CE-05-63
June 28, 2005

SPECIAL AIRWORTHINESS INFORMATION BULLETIN

(a) No.:	13
(b) Revision / Date	Revision 0 / Date 29/10/04
(b)Title:	Cracking of Weld on Triple and Quad Burner Mountings.
(c)Description:	Possible failure of weld at joint between the burner can support plate and mounting tube.
(d)Applicability:	All Shadow, Stealth and Stratus Triple/Quad Burner assemblies with gimballed burners
(e)Effectivity:	All

AD No: G-2004-0026

10. Figure 1:

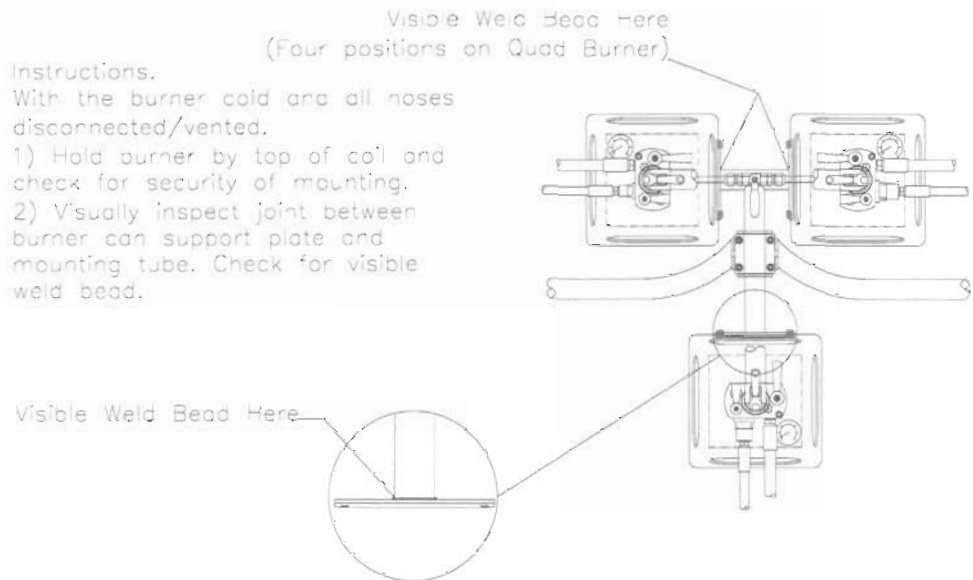
Inspect burner mounting bracket for security and correct appearance. Refer to Figure1. Non-conforming/cracked brackets must be replaced. Exchange brackets will be provided together with an instruction sheet for local replacement, or the burner can be returned to the factory. Refer to Cameron Balloons Ltd. for details.

Bracket With Correct Weld Bead

Bracket Without Correct Weld Bead

Shadow/Shadow Stealth - Triple Bracket - CB2216, Quad Bracket - CB2252.
Stratus- Triple Bracket CB8592, Quad Bracket -CB8596.
